STATE OF OHIO
 DEPARTMENT OF TRANSPORTATION
HAM US 42 10.07 READING RD
 HAMILTON, WARREN COUNTY
 CITY OF READING

REVIEW COMPLETE

IMPLEMENT TARGET SPEED PILOT PROGRAM COUNTERMEASURES ON US-42 IN THE CITY OF READING INCLUDING A ROAD DIET, ENHANCED CROSSWALKS, RRFBS, RAISED MEDIANS, IN AN EFFORT TO LOWER TRAVEL SPEEDS AND INCREASE VEHICULAR AND PEDESTRIAN SAFETY.

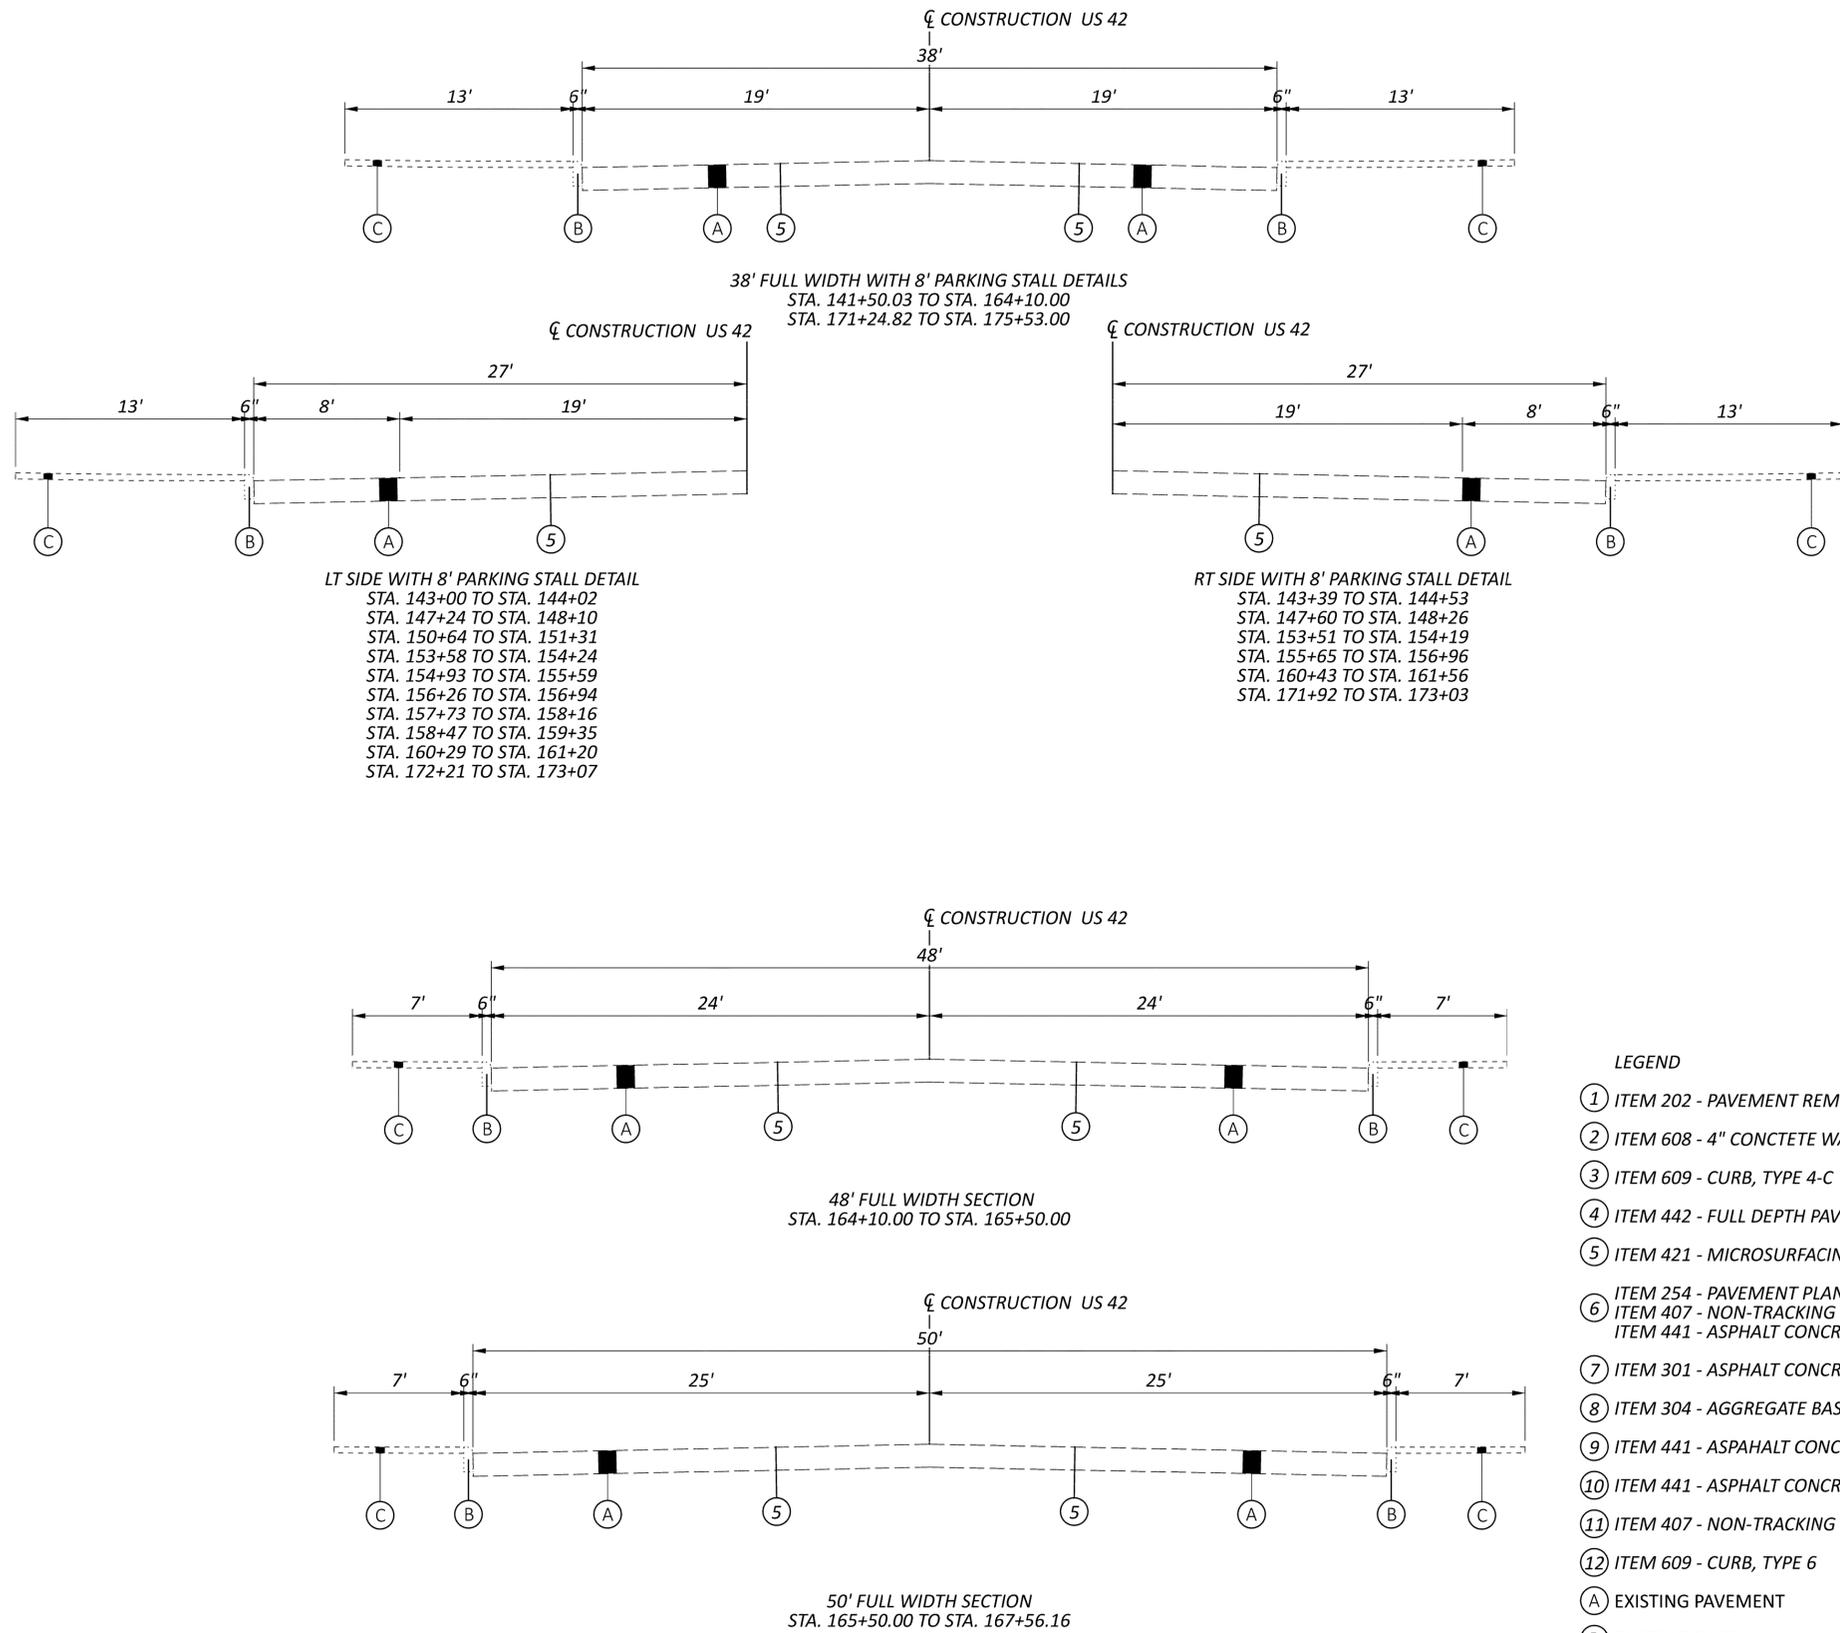
what is going back?

existing pavement to be removed and replaced with embankment?

PLAN SHEET
STA. 105+00 TO STA. 115+00

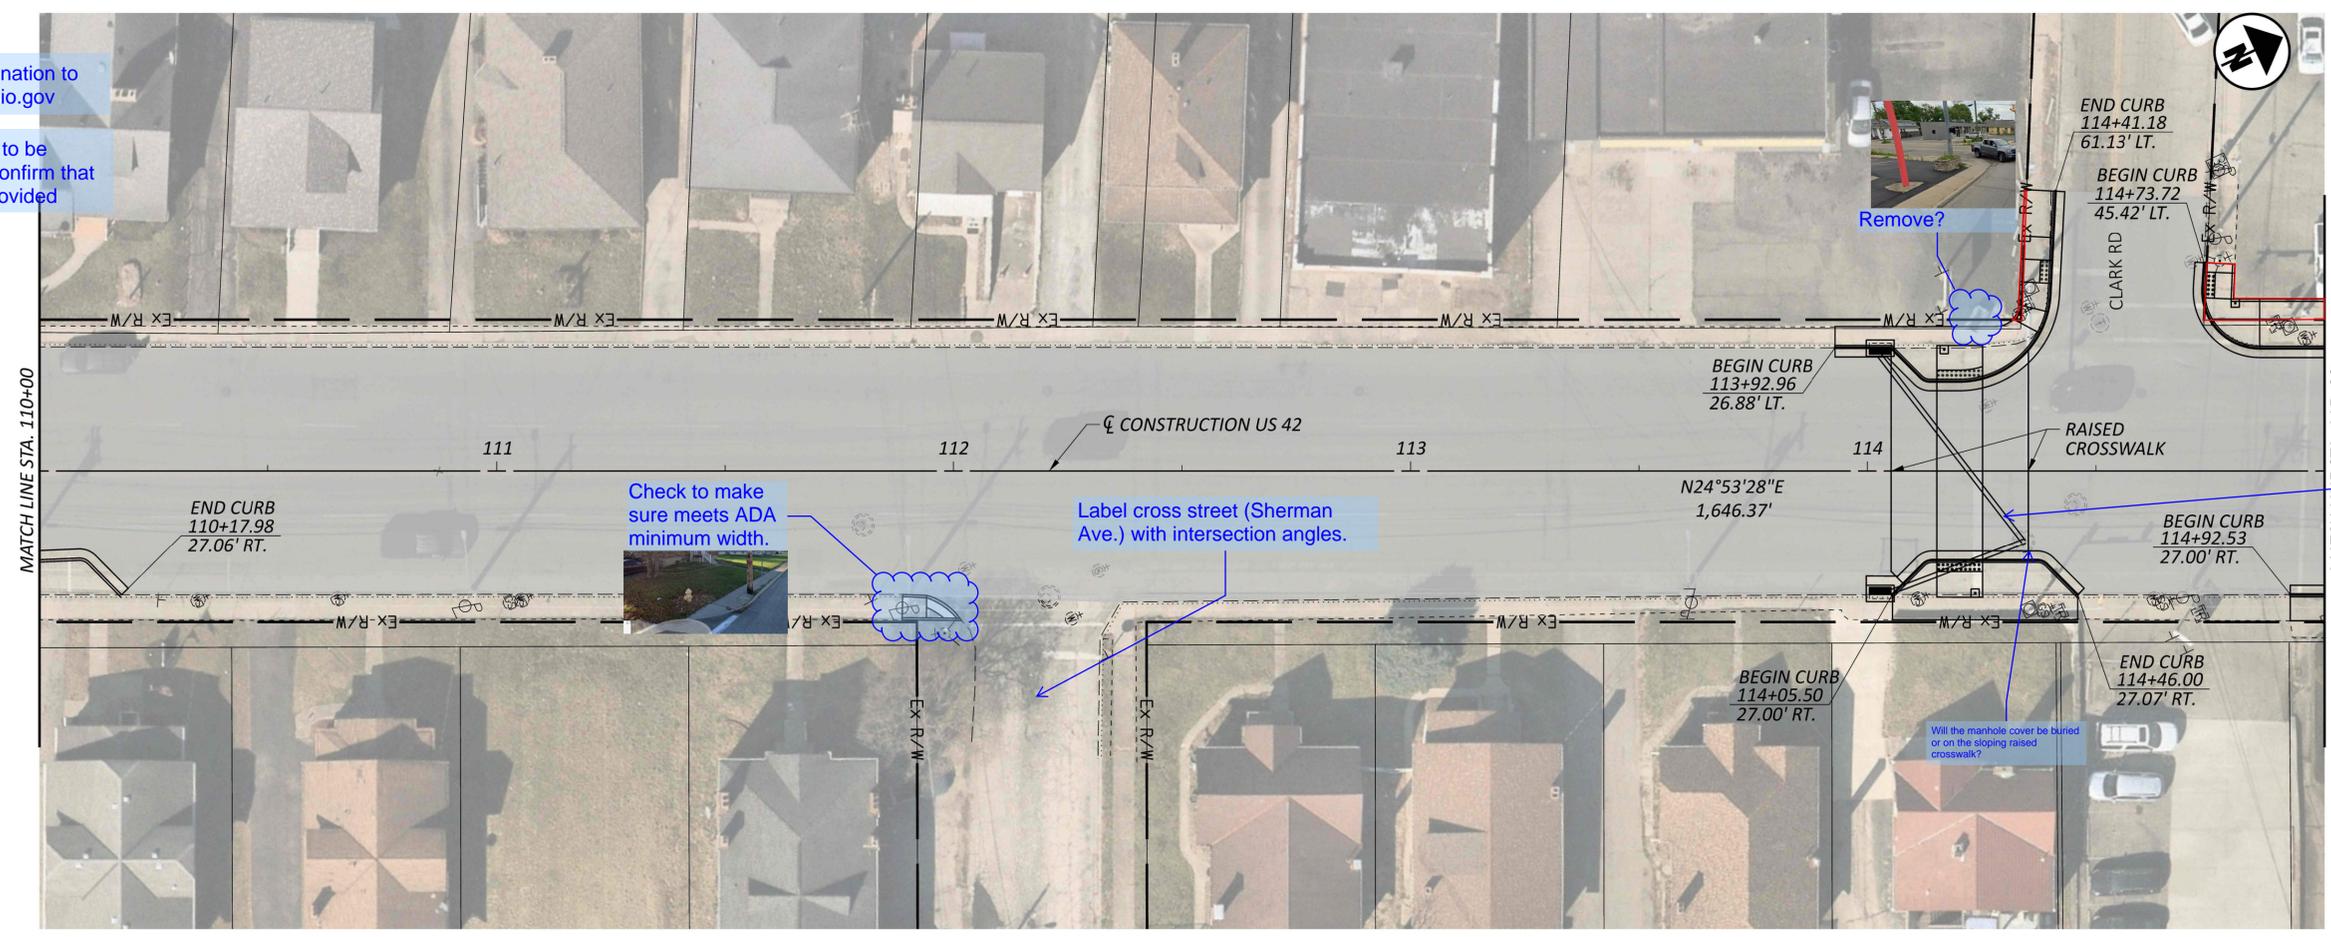
Provide utility coordination to lucas.braun@dot.ohio.gov
If any utilities need to be relocated, please confirm that sufficient R/W is provided

Check to make sure meets ADA minimum width.

Remove?

Show utilities

Will proposed storm conflict with any utilities? (typical comment)

PLAN SHEET
 STA. 195+00 TO STA. STA. 205+00

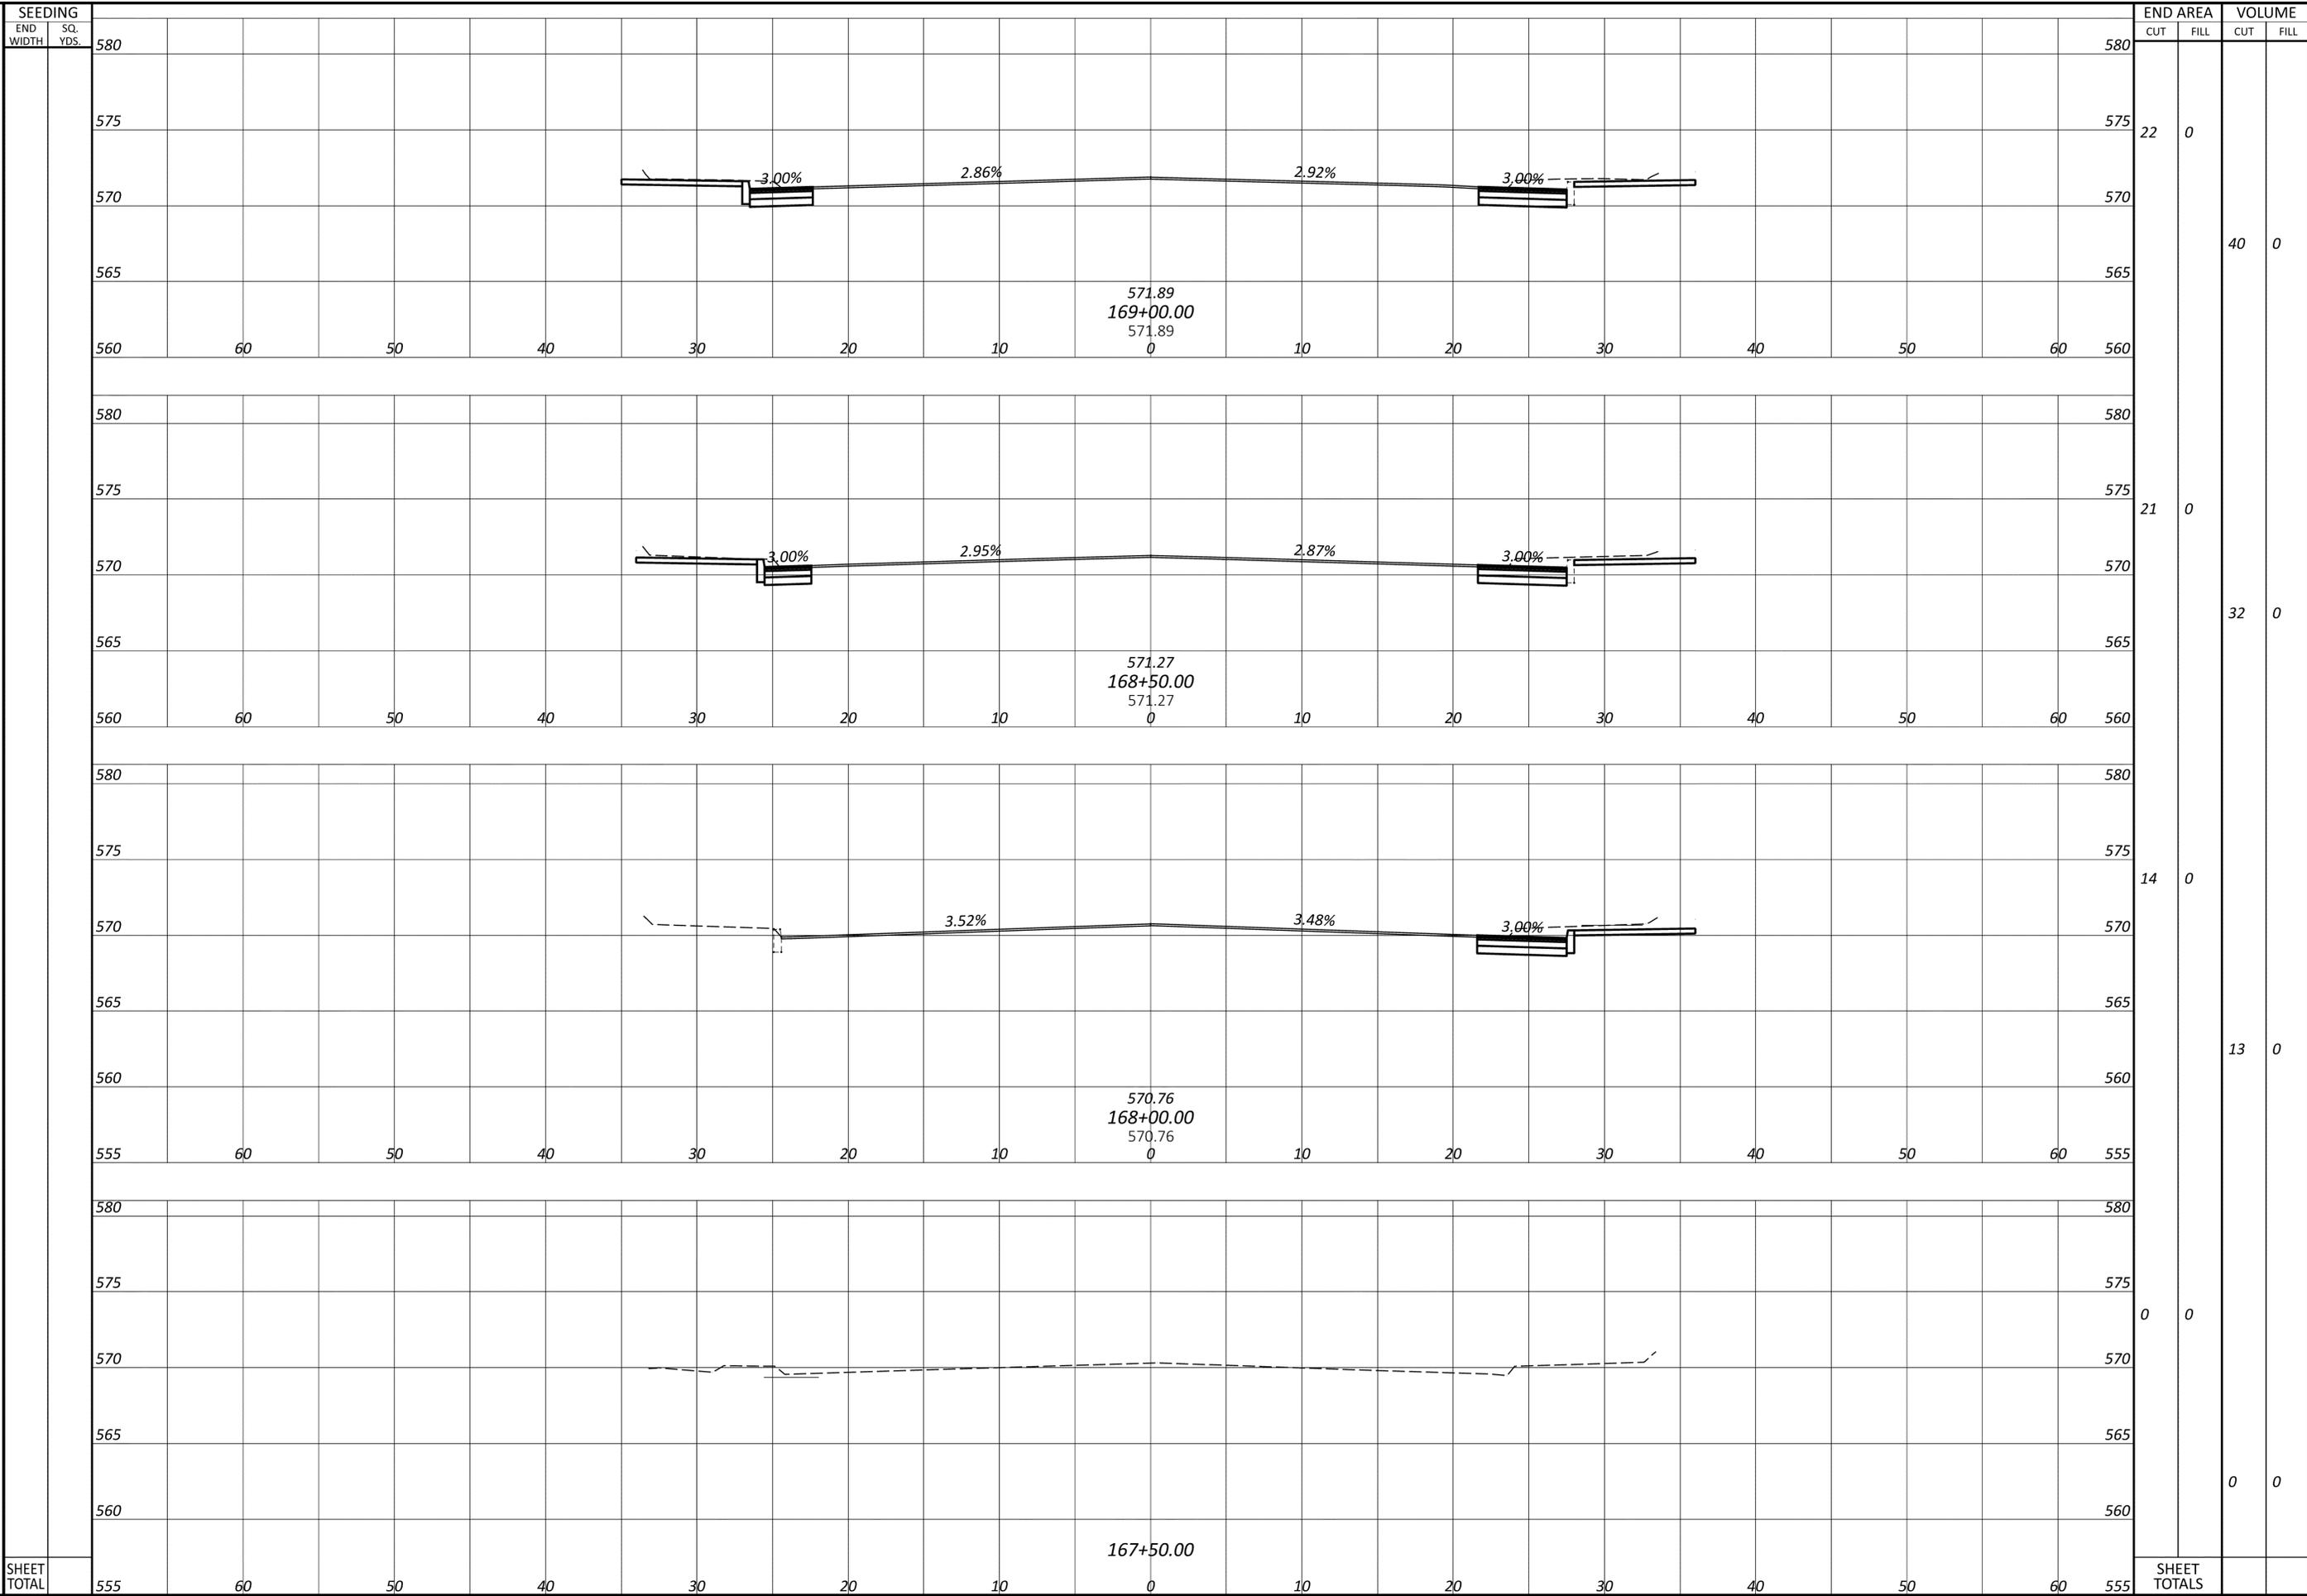
Reference sheet
 number for Matchline
